GE Energy

MFN 07-165

Subject: **Response to RAI 8.3-52 Supplement 1, and Submittal of Editorial Clarifications Related to ESBWR Design Certification Application – DCD Section 8 – Electrical Power**

DCD Section 8 Editorial Markups

Figure 8.3-21. Nonsafety-Related 480 Volt Power Centers

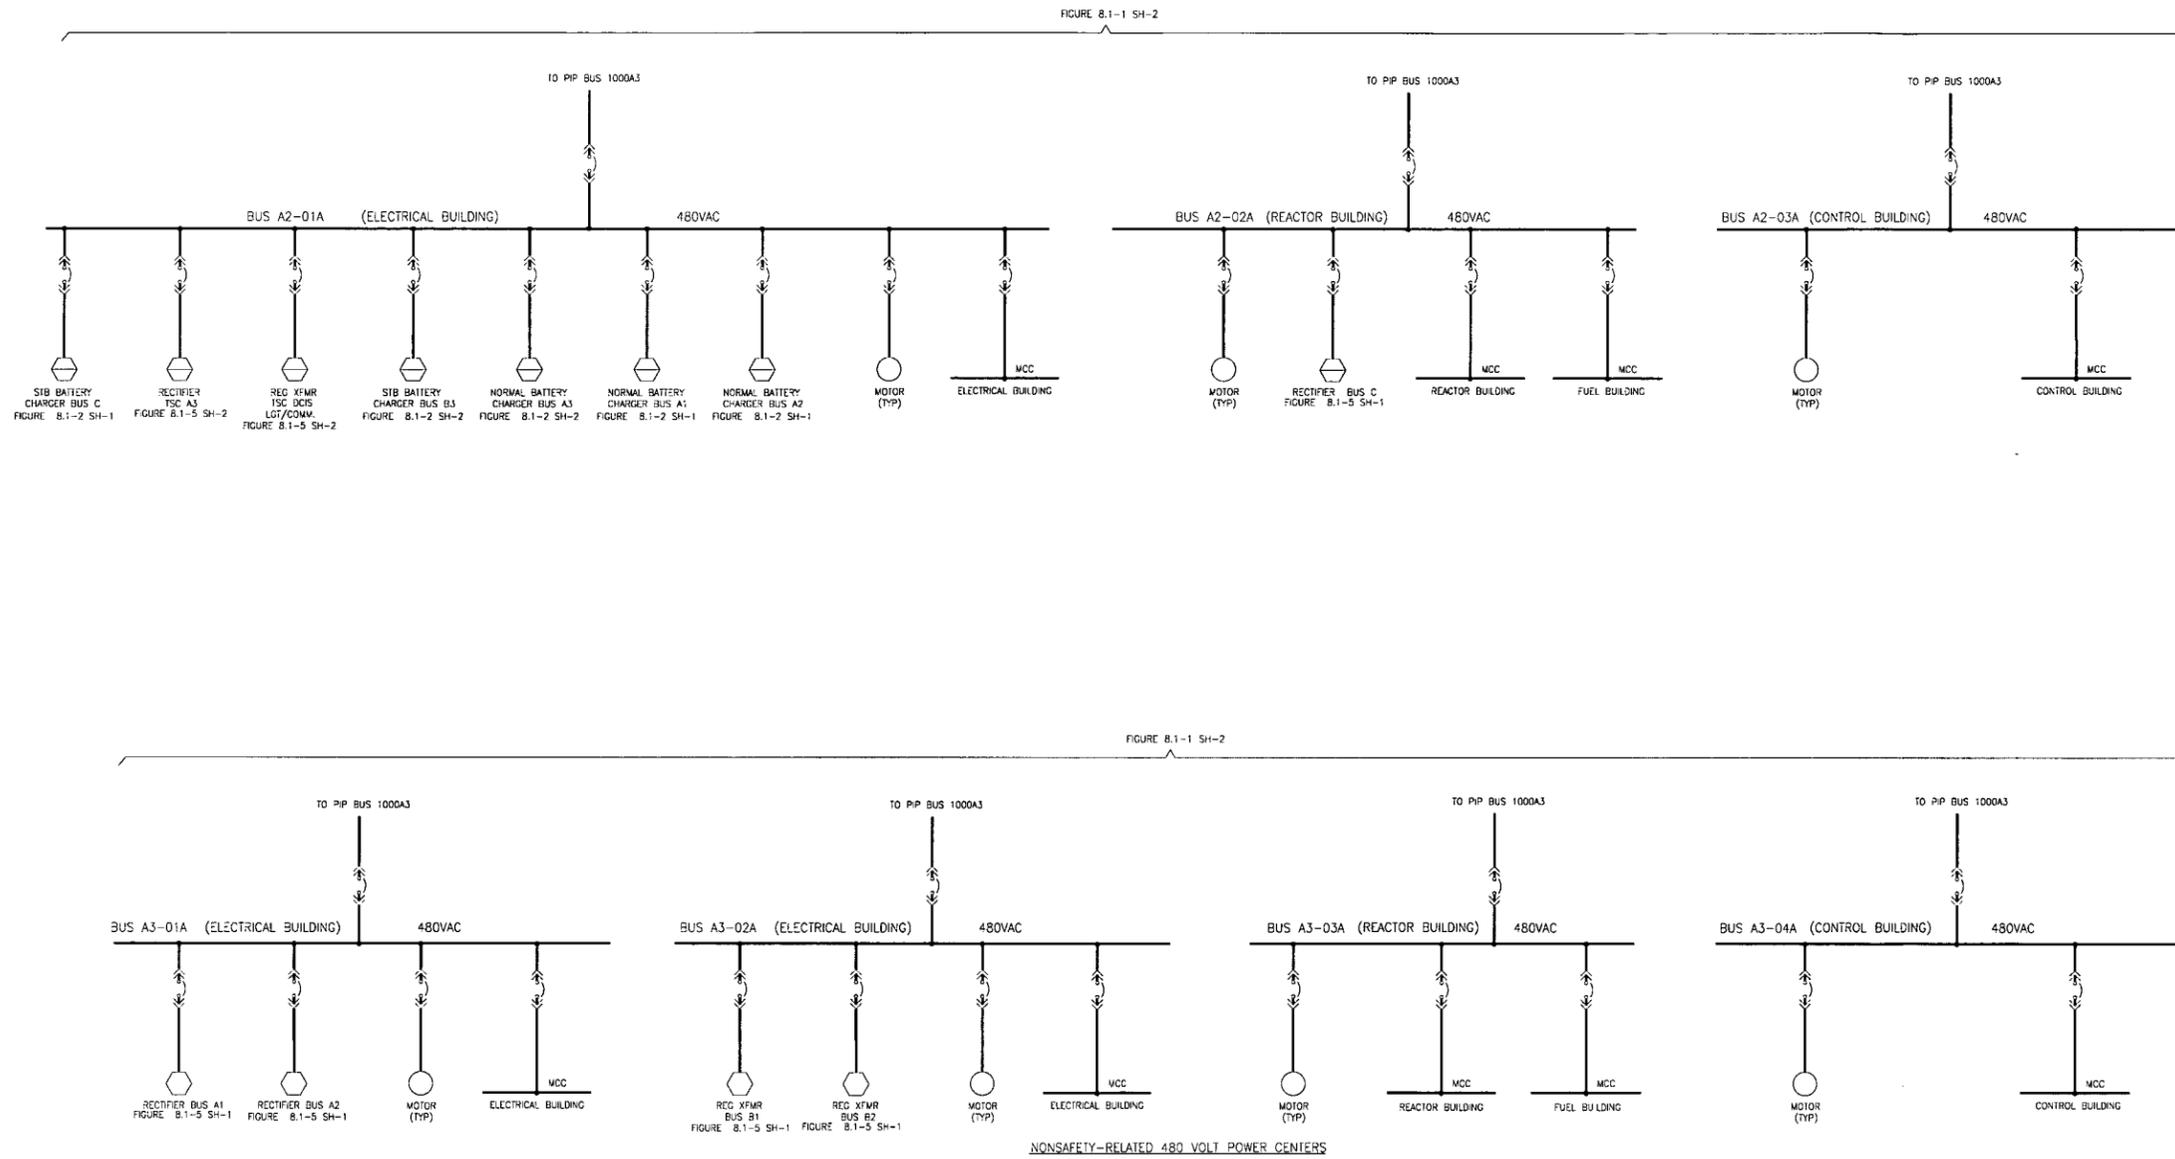
FIG. 8.3-2 SH 1 OF 3
